# Nº 143 SERVICE BULLETIN

**SUBJ:** T3™ Software Update / Match Feature

# T3™

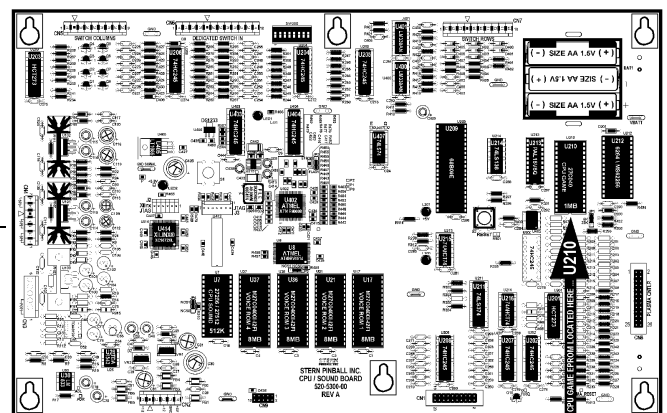
Game starts to produce only zeros (00) for the Match Number which appears at the end of every game. **Note:** Only if Standard Adjustment 13, Match Percentage, is set between 1%-10% (Default is 8%). If set at 0% or OFF, you will not see the problem noted in this bulletin.

When the Match % awarded exceeds the operators desired setting, the game will inadvertently display a "00" Match Number to prevent giving anymore Match awards (depending on your setting of Standard Adjustment 12, Match Award, Default is Credit). It may also award a Match even if the numbers do not match.

CPU Game Code **V3.01+** (SPI PN 965-0388-79) will correct this issue. You can also download it from our website via [www.sternpinball.com/techsupport.htm](http://www.sternpinball.com/techsupport.htm) and click ROM CODE LIBRARY, then the game name or direct at [www.sternpinball.com/rom.htm#12](http://www.sternpinball.com/rom.htm#12).

If your game already has v3.01 or higher, disregard this Service Bulletin (check the label on the EPROM at location U210 on your CPU Sound II Board).
